Center for Health Protection, Drinking Water Services

Re: Tidewater Reservoir Improvements Project (PR#2024-86)
City of Brookings (PWS ID#00149)
Conditional Approval

Figure 1: Water Line-Sewer Line Separation

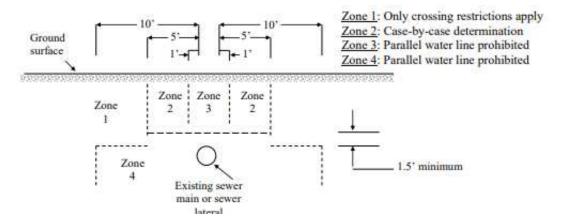
- 7. In situations involving a water line parallel to a sewer main or sewer lateral, the separation between the two shall be as indicated in the figure below (OAR 333-061-0050(9)(b)). Please confirm where the storm sewer and waterline run parallel that the storm sewer would be in Zone 2, at least 18" vertical separation and 12" horizontal separation. The trench detail did not specify the separation.
